**Prior Consultation for the Proposed Don Sahong
Hydropower Project**

TECHNICAL ASSESSMENT REPORT

Fish Passage and Fisheries Ecology

Based on submitted EIA Project Documents

Figure 3. Comparison of flows in four channels showing the change at the junction of Hou Xang Pheuak and Hou Sahong, and the reduction in high flows in Hou Phapheng.

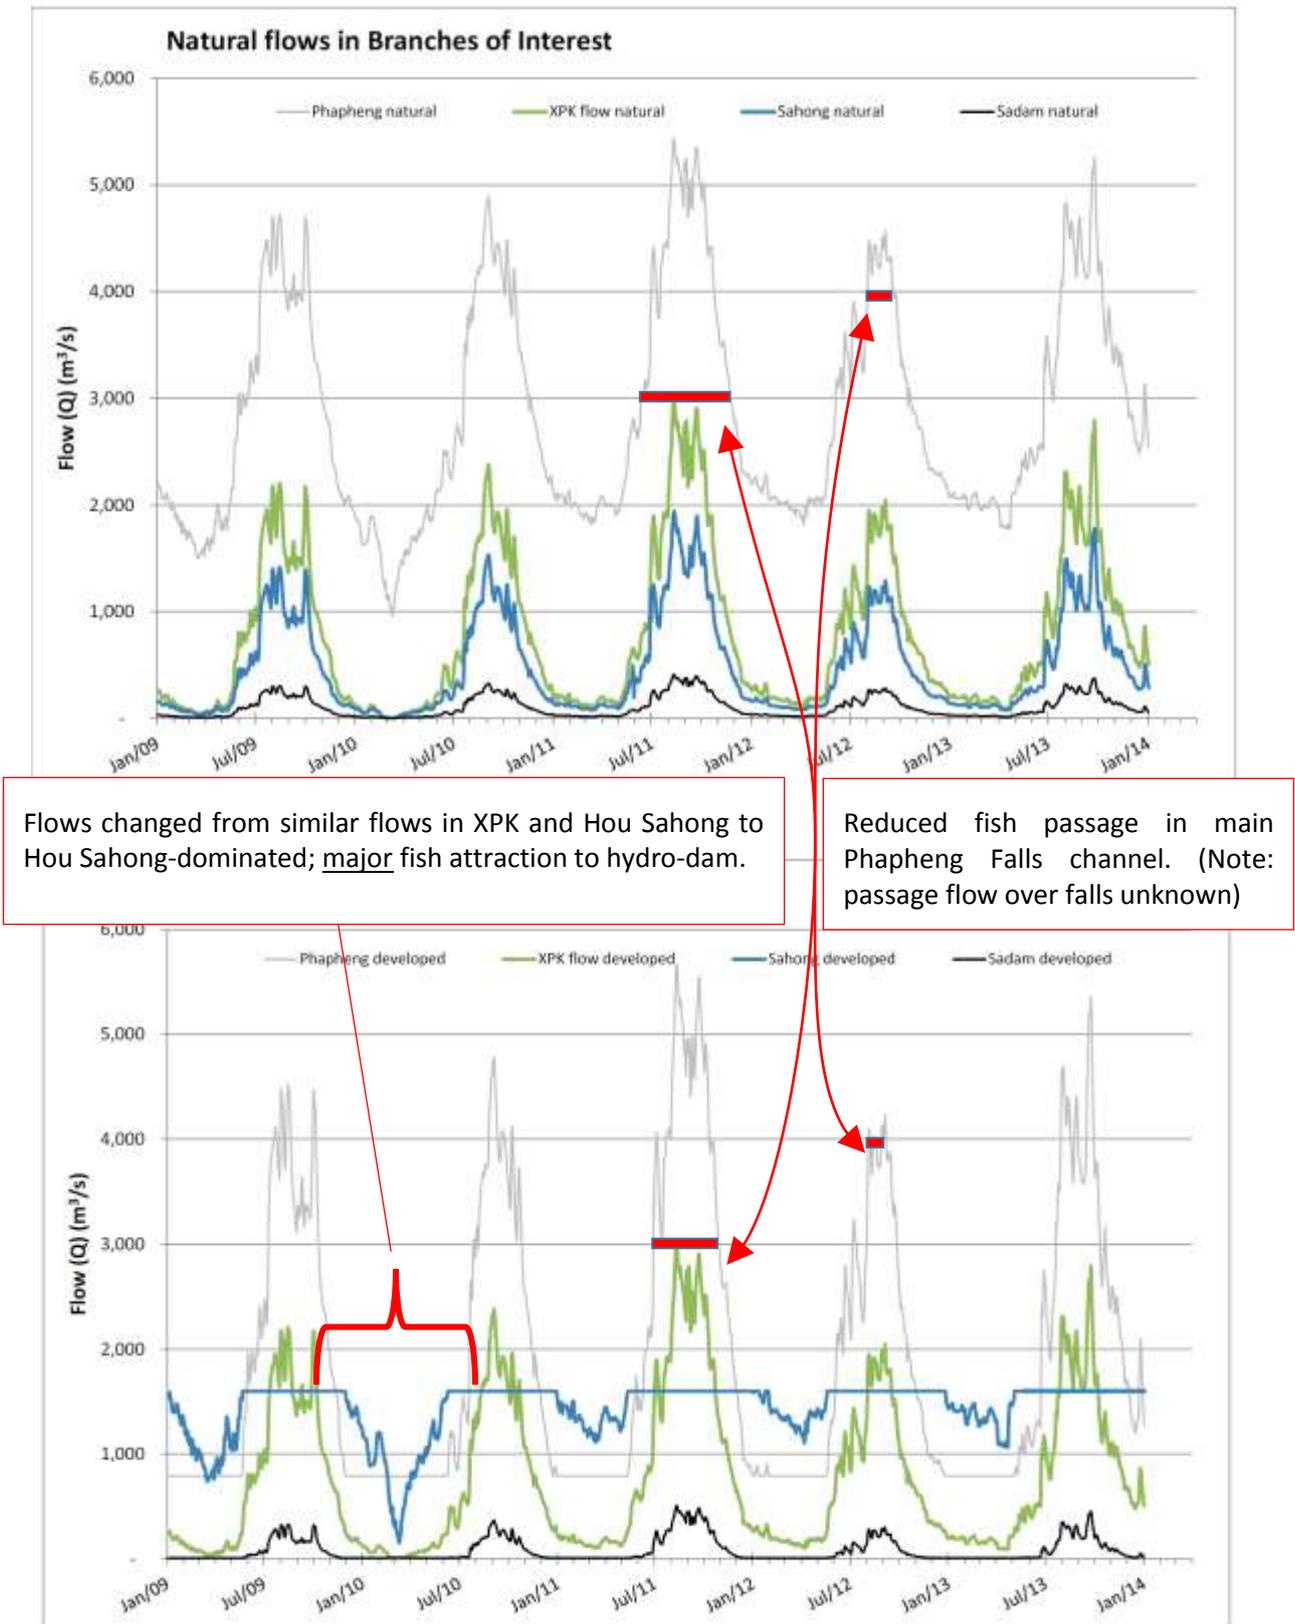
- Hydrological modelling (2009-2014) pre- and post-dam is coarse with only discharge in each of the four main channels. No information is provided on how changing flow scenarios in different seasons will change the hydraulics of the channels. Present Mike 11 modelling is focused on the inlet condition of the Hou Sahong channel and the channel itself. The western boundary of the model does not include the main western channel of the Hou Xang Pheuak inlet or any other channels west of this point. The 2D (Mike 11) modelling of Hou Sahong (Eng. Status Report) uses a 10 m by 10 m grid which is appropriate for discharge rating but is much too coarse for fish passage evaluation.

- Flows in the headwater near Hou Sahong including four main channels have been modelled and show an increase in Hou Sahong flows and a decrease in Phapheng flows (Figure 3).
- At low Mekong flows the upstream levels of Hou Xang Pheuak, Hou Sahong and Hou Sadam will be relatively lower.

Figure 4. Options for expanding fish passage at Khone Falls to compensate for lost dry season and wet season fish passage in Hou Sahong. Yellow is existing and proposed by developer, red is recommended for investigation by EG.

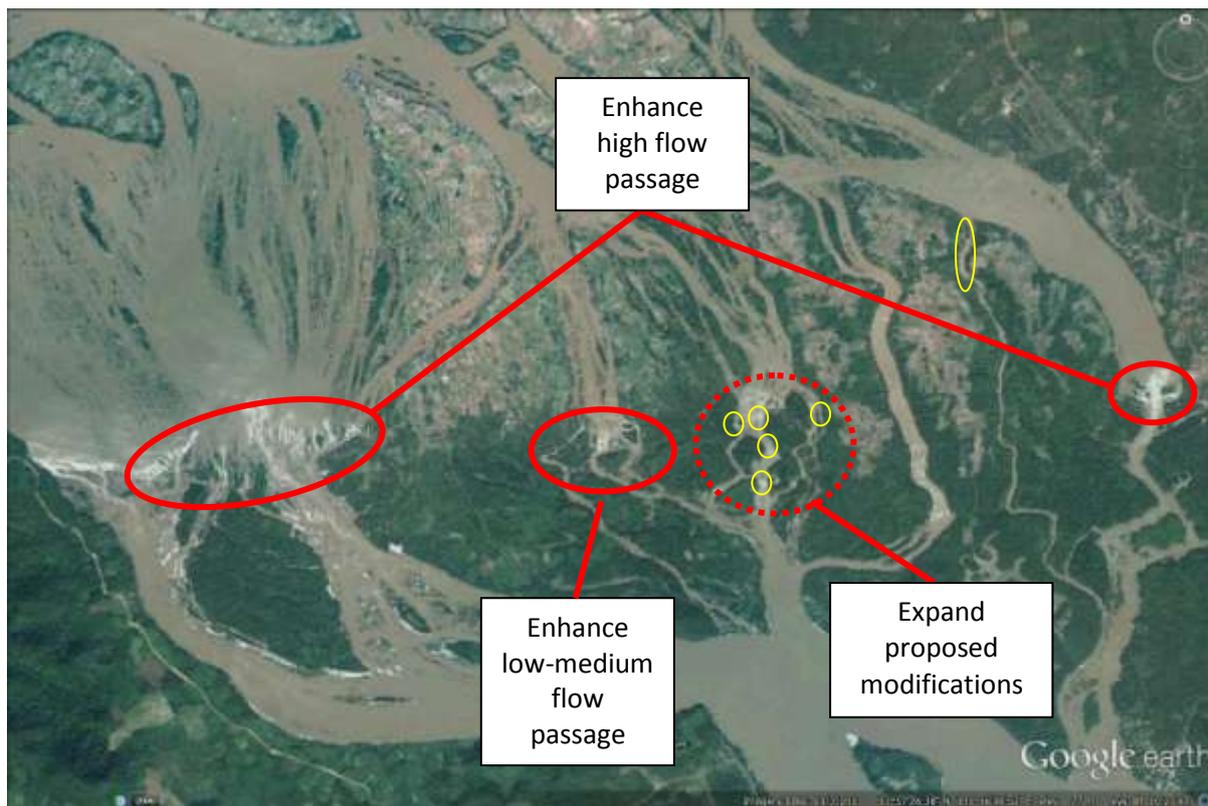
The EIA claims that the conditions in Hou Sahong will be replicated in Hou Sadam and Hou Xang Pheuak but these channels are vastly different (Figure 4; Figure 5). Hou Sahong is a single channel, whereas Xang Pheuak has several channels and hence the flow is divided between these channels and the Hou Sadam is narrow and carries considerably less flow. The EIA also states that the two systems are similar in width but the surveys and Google Earth image suggest otherwise.

- The design philosophy is to mimic hydraulic characteristics of the Hou Sahong channel but these are not documented, and the channel is fundamentally different (Figure 5) and questions remain about whether the fish will find the entrance or pass through the channel year round.

- Scale of proposed modifications in Hou Xang Pheuak is small for the channel system, and small for the whole Khone Falls site, considering it needs to compensate for the loss of Hou Sahong. Fish passage across the whole site needs to be considered, including expanding the proposed work in Hou Xang Pheuak to include all channels and not only choke points in those channels, as well high flow passage routes at Lee Pee and Khone Phapheng (Figure 4).

- Need to consider all options to compensate for lost dry season and wet season fish passage in Hou Sahong, including: fish passage in all channels; high flow passage routes (e.g. Khone Phapheng) (Figure 4), increasing discharge by deepening the inlets and channels. Presently there are only minor changes to a few channels proposed.
- Needs detailed hydraulic modelling (including ADCP field data, current meter data, and 3D CFD modelling) at minimum and a range of flows of all channels, especially the Hou Sahong, Hou Xang Pheuak and Hou Sadam channels before and after any modification.

To mitigate the loss of passage in Hou Sahong it is recommended that the scope of upstream passage be expanded to more sites and channels to provide for high flow and low flow passage (see below). The technical scope also needs to be expanded and it is recommended that fish passage experts are engaged to guide the final design of fish passage for upstream and downstream.

Figure 6. Proportion of Mekong flow passing through Hou Sahong pre- and post-operation.

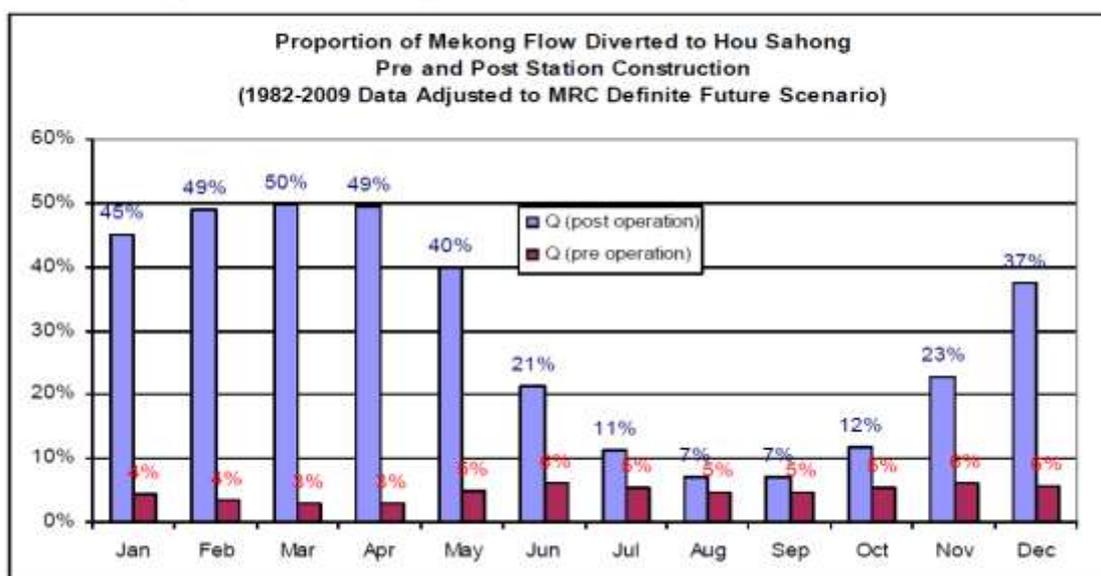
Downstream migration would be affected by passage through the turbines, which can injure and kill fish, and the change in hydrology between the different channels, which changes the hydraulics (depth, water velocity, turbulence). Downstream passage of fish through the turbines is a significant issue as up to 50% of Mekong flow passes through Don Sahong in dry season and 7% in the wet season (Figure 6).
